SUBJECT: Crystal River Unit 3  
Docket No. 50-302  
Operating License No. DPR-72

On September 19, 1979, Florida Power Corporation received your letter dated September 7, 1979 requesting additional information concerning the upgrade of the anticipatory reactor trips on turbine trip or loss of main feedwater at Crystal River Unit 3.

NEW SAFETY-GRADE REACTOR  
TRIPS FOR RPS-I

RPS TRIP ON LOSS OF MAIN FEEDWATER (SIMPLIFIED) Figure 1

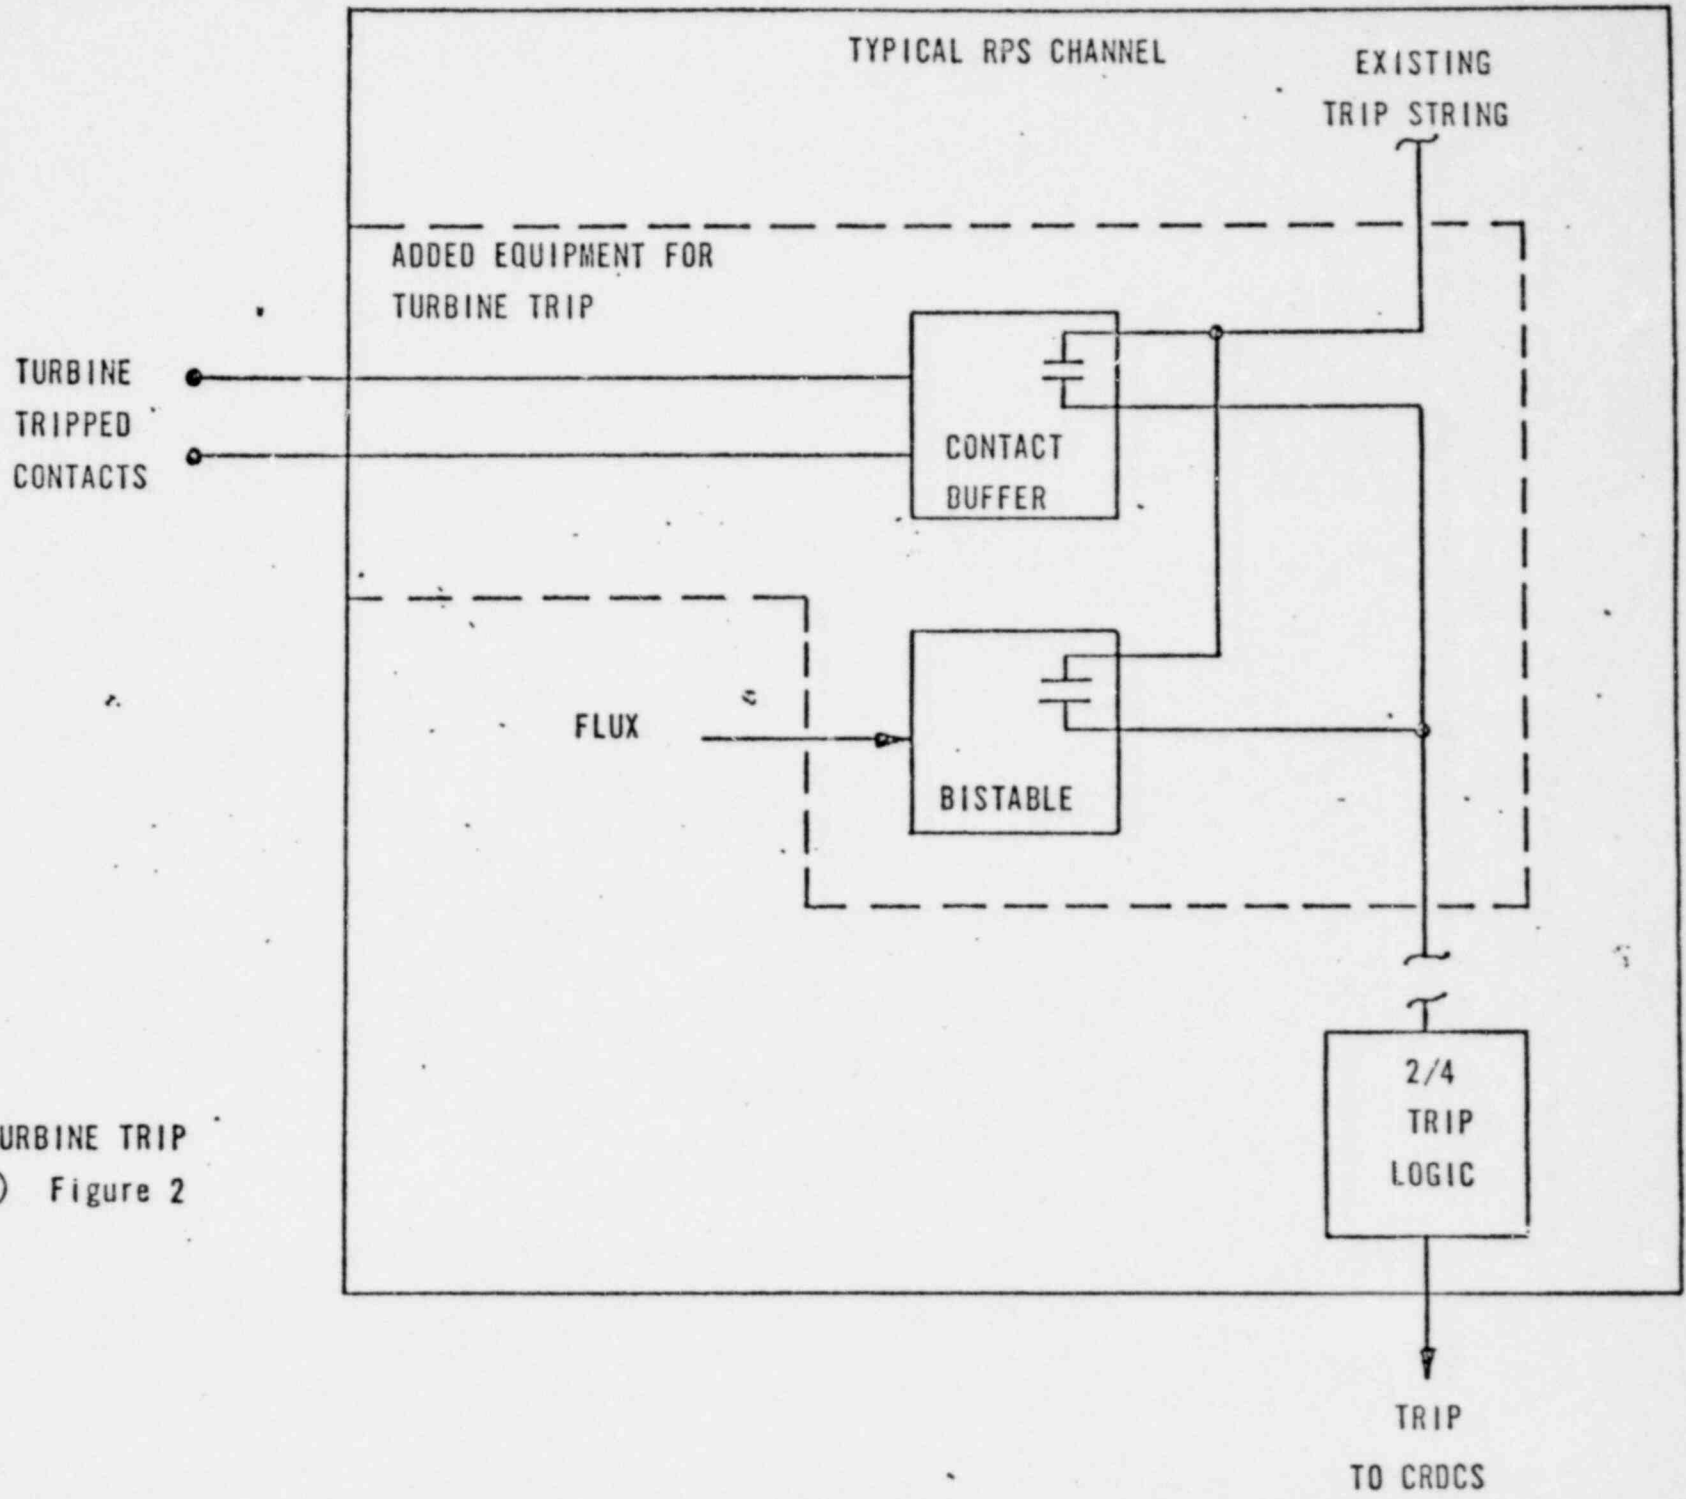
QUESTION 3. Provide a description of any changes to and/or interfaces with the existing protection system. Include diagrams (block, location, functional and/or elementary wiring), as necessary, to clearly depict the changes and/or interfaces. In addition, provide an analysis which demonstrates that these changes and/or interfaces will not degrade the existing protection system.

Loss of Main Feedwater Trip - Control oil pressure switches on both main feedwater pumps will input an open indication to the RPS on feedwater pump trip. Contact buffers in the RPS will sense the contact inputs and initiate an RPS trip when both pumps have tripped. This trip will be bypassed below a predetermined flux level, typically 20% FP. Reference Figure 1.

The anticipatory trip equipment will be added to the RPS cabinets and will interface as new trips in the present bistable trip string. Figures 1 and 2 of the Attachment I show the functional interface of the added equipment with the RPS. Drawings 51079DBG-1 and 51079MLG-1 of the attachment describe the inputs, outputs, and logic of the new trip functions. The added modules will consist of contact buffers, bistables, and auxiliary relays, which have been tested and qualified for use in the safety system. Existing RPS power supplies, flux signals, interlock circuits, and indicators will be used as required by the added equipment. The requirements for the RPS, e.g., cooling, power, seismic, environmental, will be the same for the system with anticipatory trips as the requirements prior to addition of the new trips.

RPS TRIP ON TURBINE TRIP  
(SIMPLIFIED) Figure 2

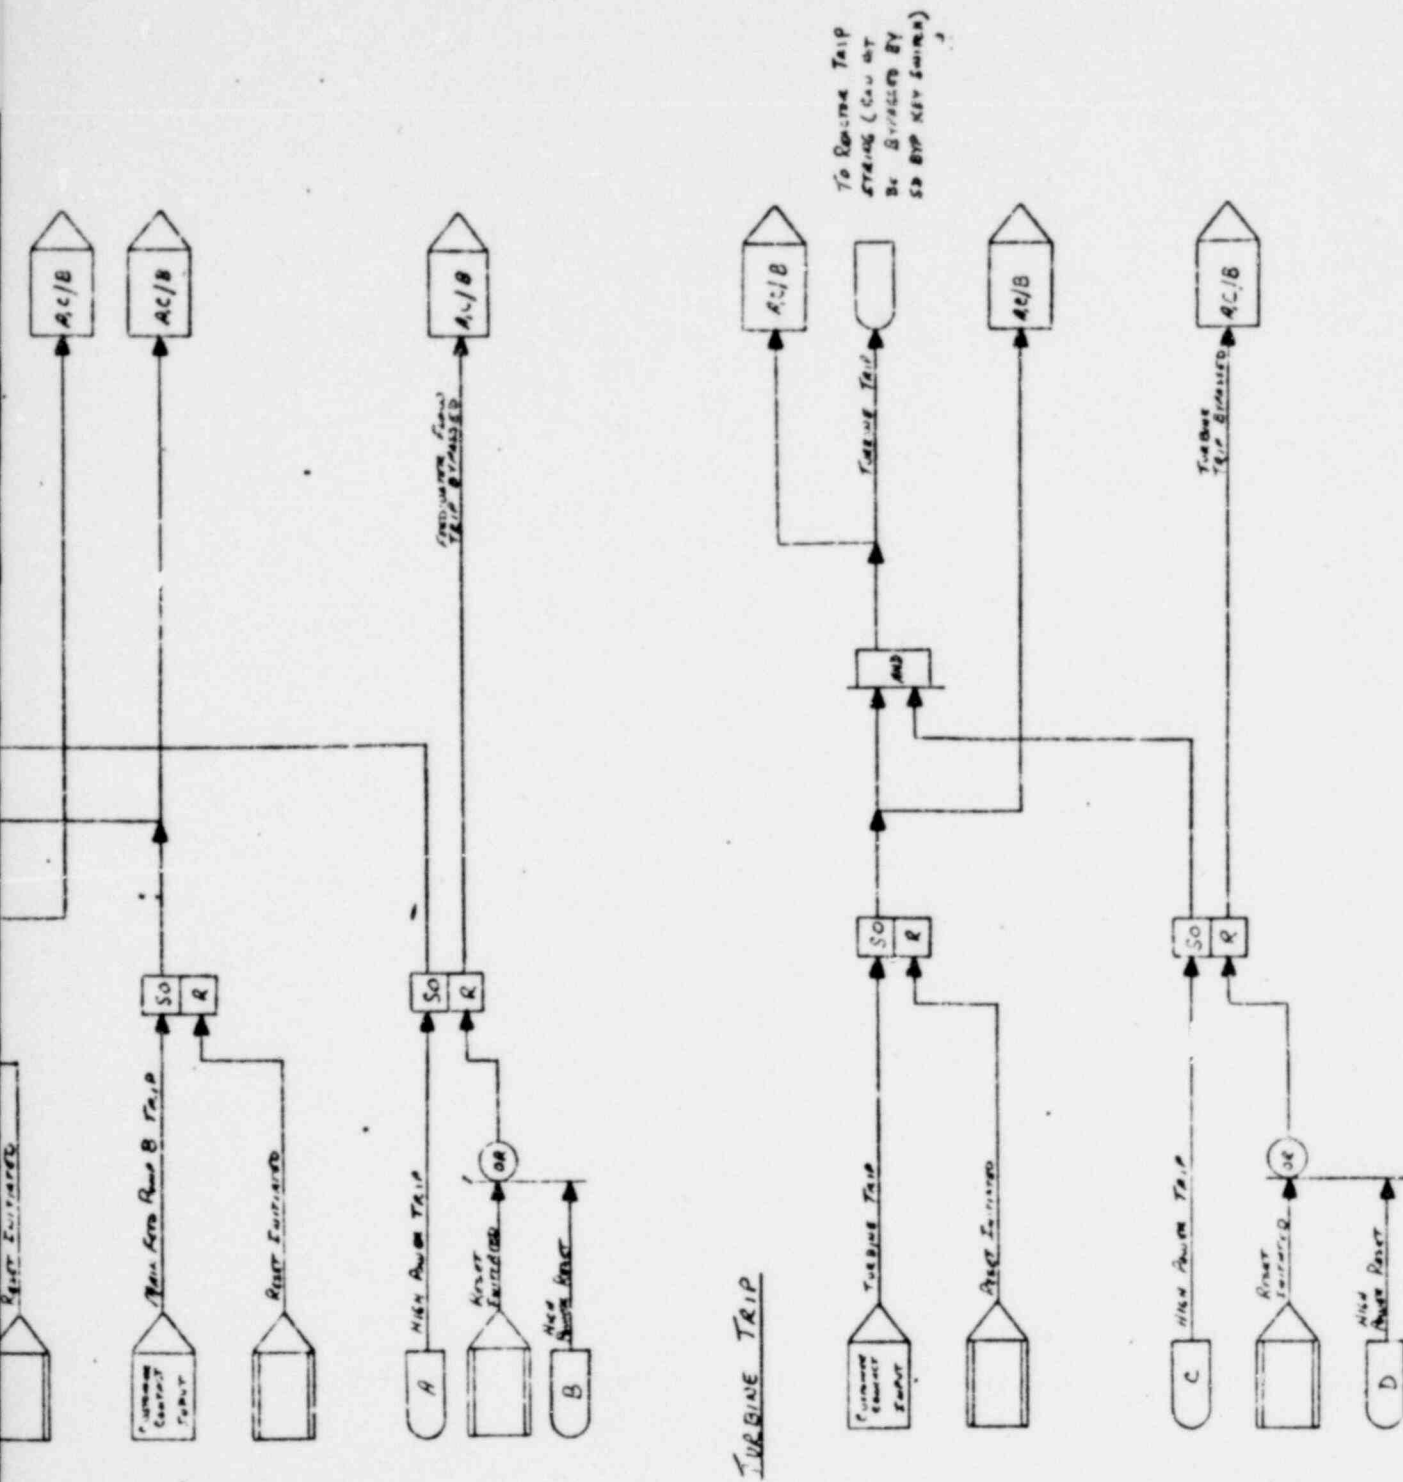
Turbine Trip - Contact outputs from the main turbine electro-hydraulic control unit will input an open indication to the RPS on turbine trip. Contact buffers in the RPS will sense the contact inputs and initiate an RPS trip when a turbine trip is indicated. This trip will be bypassed below a predetermined flux level, typically 20% FP. Reference Figure 2.

FIGURE 9a-1

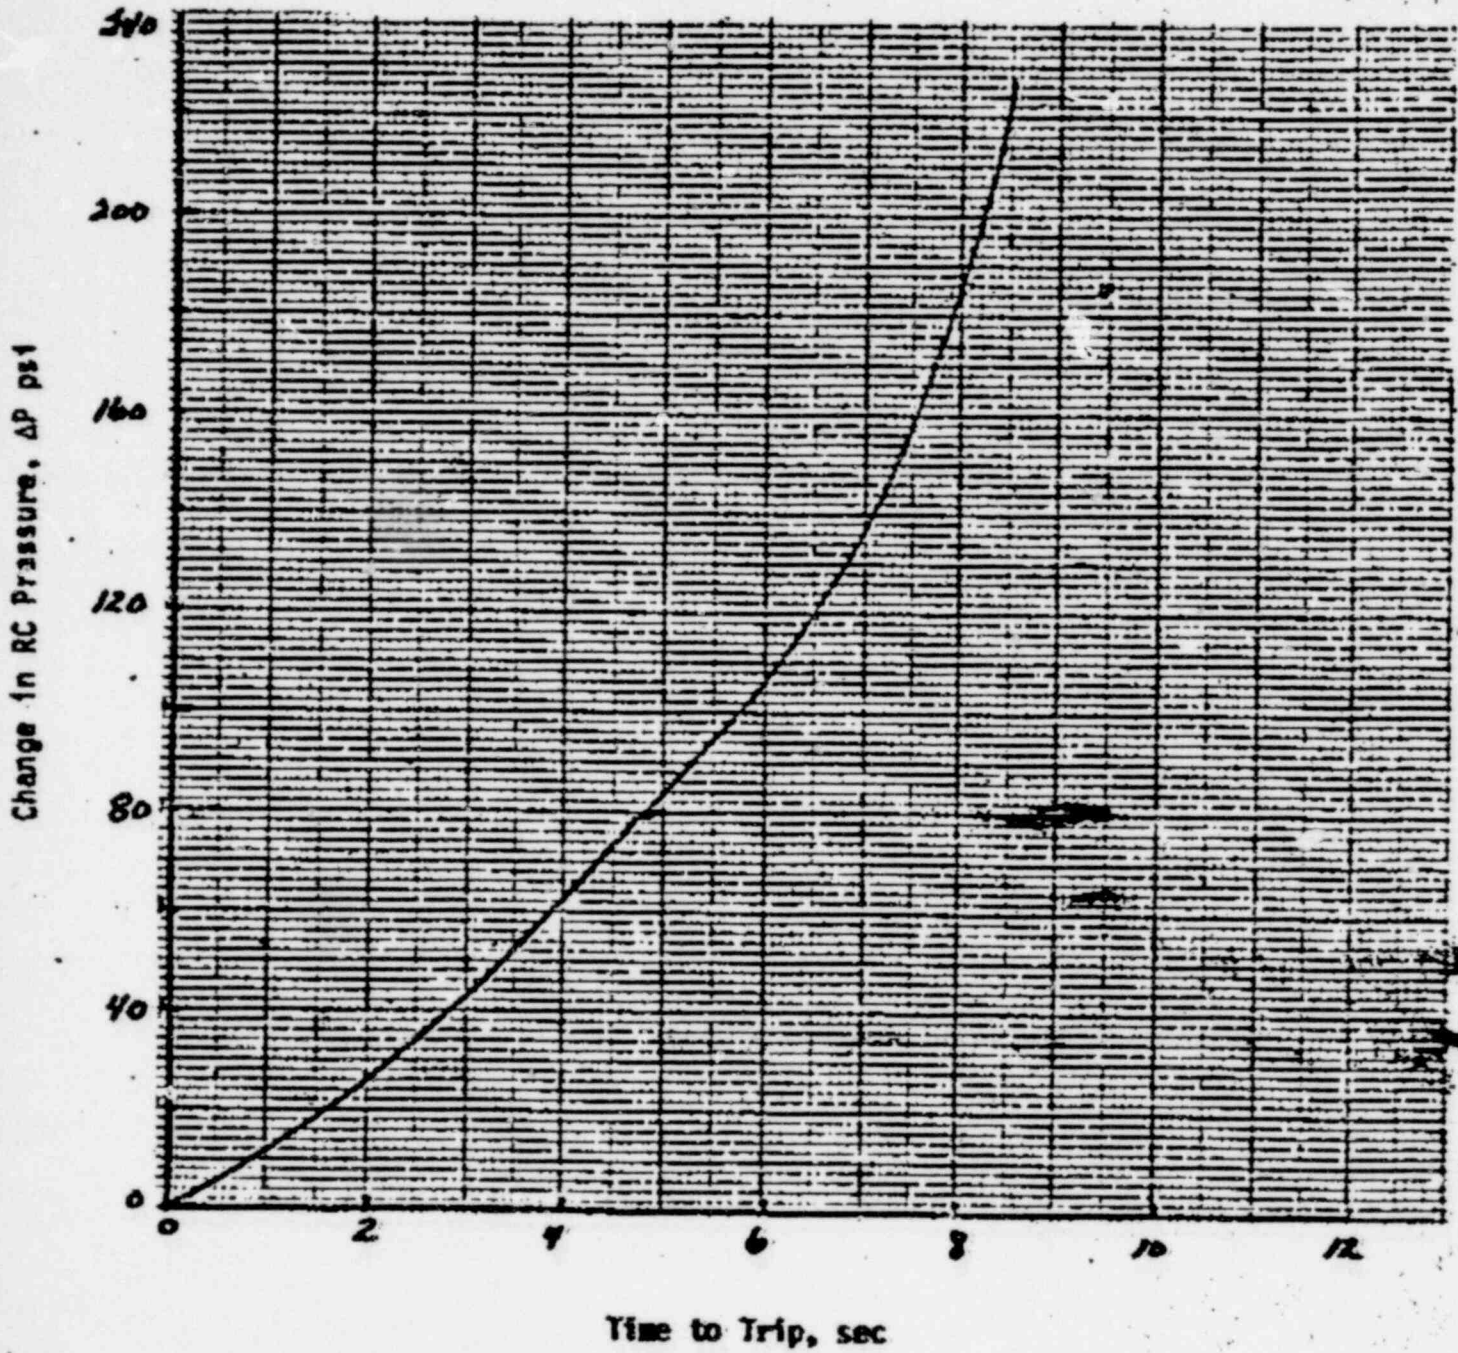
- a. Provide an analysis that quantifies the improvement in the time-to-reactor-trip for both the turbine trip and the loss of main feedwater signals;
- b. Address the need to bypass these trips at 20% power versus bypass at a lower power (approximately 10%);
- c. Discuss the adequacy of the proposed trip signals for loss of main feedwater for a variety of failure scenarios (such as feedwater valve closures), i.e., see the Oconee 1 transients of 6/11/79; and
- d. Provide an evaluation of why a reactor trip on low steam generator level is not a viable anticipatory trip signal when the other signals are bypassed, i.e., see the Crystal River 3 transient of 8/2/79.

- a. The primary purpose of anticipatory reactors trips (ARTs) is to reduce the probability of lifting the PORV for turbine trip/loss of main feedwater type events. For a reactor high pressure trip setpoint of 2300 psig, it was shown in References 1 and 2 that the PORV would not lift with a setpoint of >2400 psig. The margin to the PORV setpoint can be increased, however, by use of ARTs. Figure 9a-1 shows the pressure increase from nominal operating pressure as a function of time to trip for the loss of main feedwater event. From this figure, it can be seen that an ART that detects and trips the plant at 4 seconds results in a peak pressure increase of 60 psi; whereas the high R.C. pressure trip which would occur at 8 seconds results in a peak pressure increase of 184 psi. The anticipatory trip signals which have been selected will initiate a reactor trip in less than one second. As seen on Figure 9a-1, a one second time to trip results in a 12 psi pressure increase, compared to a 184 psi pressure increase for the high pressure trip at 8 seconds.
